Access Compliance Report

Public Rights-of-Way

(Curb Ramps)

Intersection ID: 31418	Main Street: CHEVIOTT_HILL_LN	Cross Street: GUILDHALL_LN	Location: SW
ADA ID: 37496AACD678	Ramp Type: PerpDiag	Initial Pass/Fail: Fail	Overall Compliance: No
Severity Score: 46.25			
Codes/Mitigation Info/Possible Solution		Field Measurements/Component Compliance

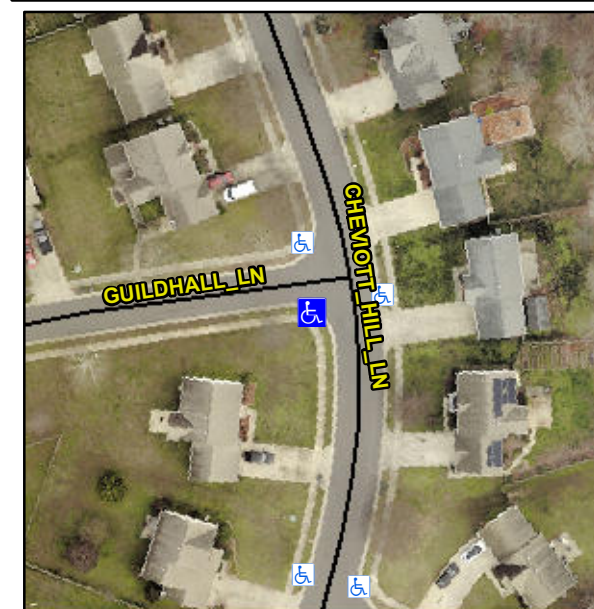
R304.5.1, R304.2.2, R304.5.3

Compliance	Description	Data	Compliance	Description	Data
N/A	Ramp Length (in)	47.0	No	Ramp Slope (%)	9.5
No	Ramp Width (in)	37.5	No	Ramp XSlope (%)	8.5
N/A	Flare Type LT	N/A	N/A	Flare Type RT	N/A
N/A	Flare Slope LT (%)	N/A	N/A	Flare Slope RT (%)	N/A
N/A	Flare Traversable LT?	N/A	N/A	Flare Traversable RT?	N/A
N/A	Landing Length (in)	N/A	N/A	DWS Provided?	N/A
N/A	Landing Width (in)	N/A	N/A	DWS Contrast?	N/A
N/A	Landing Slope (%)	N/A	N/A	DWS Length (in)	N/A
N/A	Landing X Slope (%)	N/A	N/A	DWS Full Width?	N/A
N/A	Landing Curb? (Y/N)	N/A	N/A	DWS Offset (in)	N/A
N/A	Shared Landing?	N/A			
N/A	Gutter Ponding?	N/A	N/A	Gutter Slope (%)	N/A
N/A	Gutter Lip Ht (in)	N/A	N/A	Gutter X Slope (%)	N/A
N/A	Painted X Walk1?	No	N/A	Painted X Walk2?	No
	X Walk 1 Direction	To E		X Walk 2 Direction	To N
N/A	X Walk 1 Width (in)	N/A	N/A	X Walk 2 Width (in)	N/A
	X Walk 1 Slope (%)	7.8		X Walk 2 Slope (%)	2.7
	X Walk 1 X Slope (%)	3.4		X Walk 2 X Slope (%)	8.9

N/A	Ramp inside XWalk1?	N/A	N/A	Ramp inside XWalk2?	N/A
	Road Slope (%)	6.6	N/A	Clear Space?	N/A
	Road X Slope (%)	6.9	N/A	Clear Space to XWalk (in)	N/A
N/A	Any Obstructions?	N/A	N/A	Storm Grate/Utility Hazard?	N/A
	Obstruction Type			Storm Grate/Utility Type	
		N/A			N/A
			Yes	Surface Condition? (G/P)	Good

Remove & Replace Curb Ramp With Two New Directional Ramps or Equivalent.
